**Economic and Social Council**Distr.: General
20 October 2017

Economic Commission for Europe**Inland Transport Committee****World Forum for Harmonization of Vehicle Regulations****Working Party on Pollution and Energy****Seventy-sixth session**

Light vehicles – Global Technical Regulations Nos. 15**(Worldwide harmonized Light vehicles Test Procedures (WLTP))****and 19 (Evaporative emission test procedure for the Worldwide****harmonized Light vehicles Test Procedure (WLTP EVAP))****Proposal for Amendment 1 to global technical regulation
No. 19 (Evaporative emission test procedure for the
Worldwide harmonized Light vehicles Test Procedure
(WLTP EVAP))****Submitted by the Informal Working Group on Worldwide harmonized
Light vehicles Test Procedure (WLTP)***

Amendment 1 to global technical regulation No. 19 on Evaporative emission test procedure for the Worldwide harmonized Light vehicles Test Procedure (WLTP EVAP)

Figure A1/21
Canister bench ageing procedure

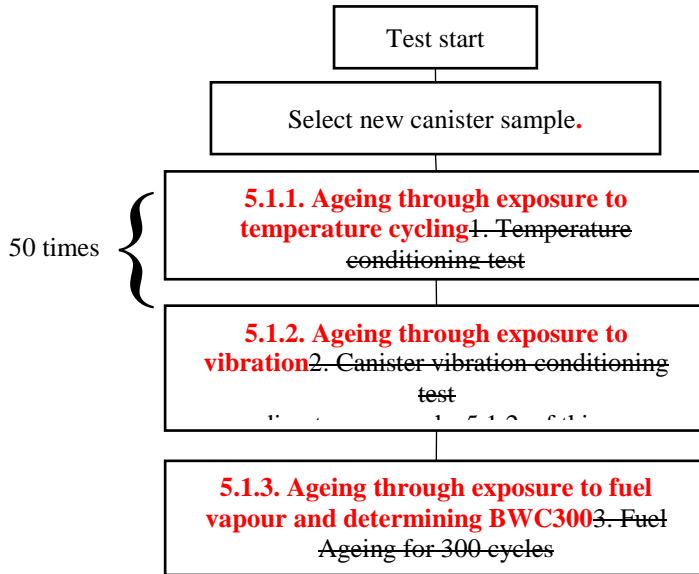
Before performing the hot soak and diurnal losses sequences, the canister shall be aged according to the procedure described in Figure A1/21.

Figure A1/32
Temperature conditioning cycle

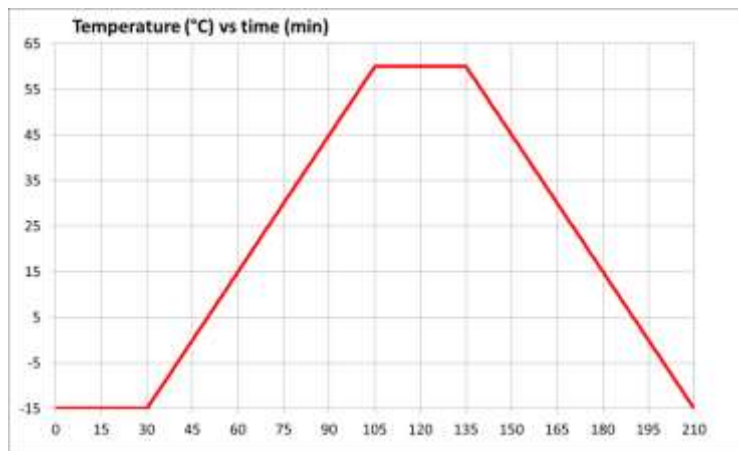
The canister shall be cycled between temperatures from -15 °C to 60 °C in a dedicated temperature enclosure with 30 minutes of stabilisation at -15 °C and 60 °C. Each cycle shall last 210 minutes (see Figure A1/32).

The temperature gradient shall be as close as possible to 1 °C/min. No forced air flow should pass through the canister.

The cycle shall be repeated 50 times consecutively. In total, this procedure lasts 175 hours.

Figure A1/43

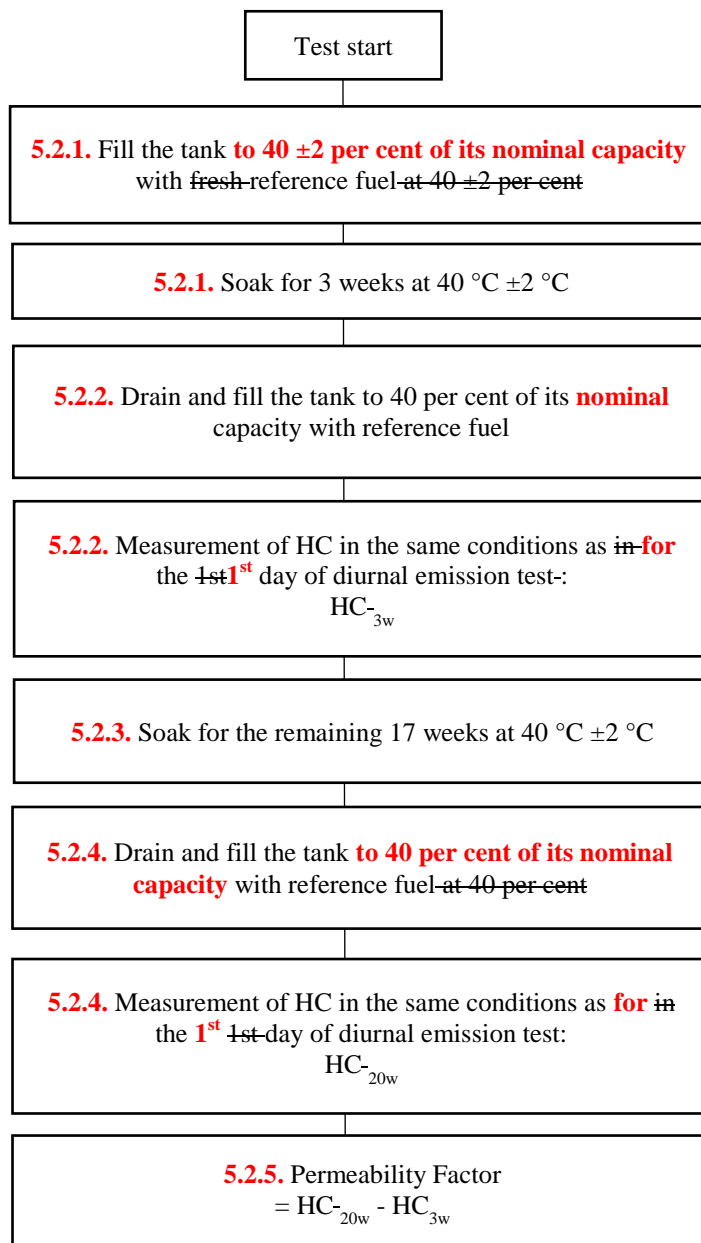
5.2. Determination of the ~~Permeability Factor (PF)~~ of the fuel tank system (~~see~~ **see** Figure A1/43)

- 5.2.1. **The fuel tank system representative of a family shall be selected and mounted on a rig in a similar orientation as in the vehicle.** The tank shall be filled **to 40 ±2 per cent of its nominal capacity** with ~~fresh~~-reference fuel at a temperature of 18 °C ±2 °C. ~~The tank shall be filled to 40 ±2 per cent of the nominal tank capacity.~~ The rig with the fuel tank system shall be placed in a room with a controlled temperature of 40 °C ±2 °C for 3 weeks.
- 5.2.2. At the end of the third week, the tank shall be drained and refilled with ~~fresh~~-reference fuel at a temperature of 18 °C ±2 °C to 40 ±2 per cent of ~~its~~ **the** nominal tank capacity.
- Within 6 to 36 hours, the rig with the fuel tank system shall be placed in an enclosure. The last 6 hours of this period shall be at an ambient temperature

of 20 °C ±2 °C. In the enclosure, a diurnal procedure shall be performed over ~~the a first period of 24~~ **24-hours period** of the procedure described in paragraph ~~5.3.9~~ **6.5.10** of this annex. The fuel **vapour in the** tank system shall be vented to the outside of the enclosure to eliminate the possibility of the tank venting emissions being counted as permeation. The HC emissions shall be measured and the value shall be recorded as HC_{3W}.

Figure A1/4
Flow of the test procedure

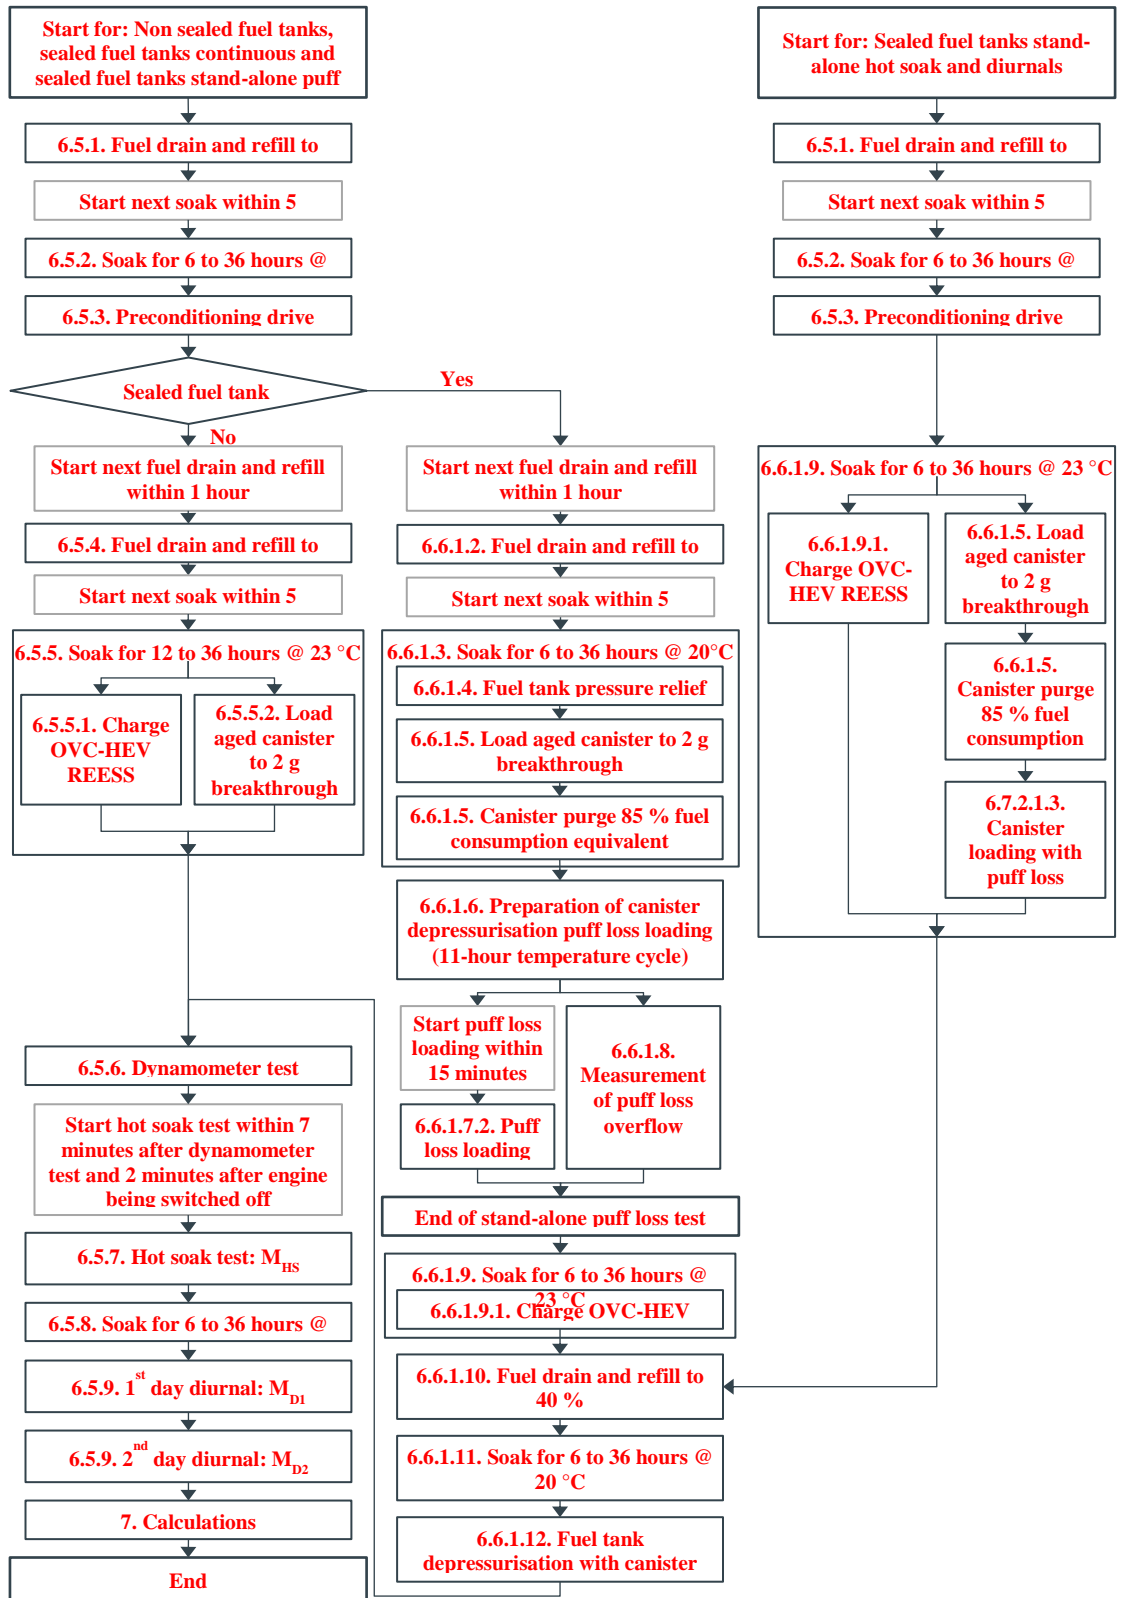
The test procedure for non-sealed and sealed tank systems shall be followed according to the flow chart described in Figure A1/4.

The sealed fuel tank systems shall be tested with 2 options. One option is to test the vehicle with one continuous procedure. Another option, called the stand-alone procedure, is to test the vehicle with two separate procedures which will allow to repeating the dynamometer test and the diurnal tests without repeating the tank depressurisation puff loss overflow test and the depressurisation puff loss measurement.
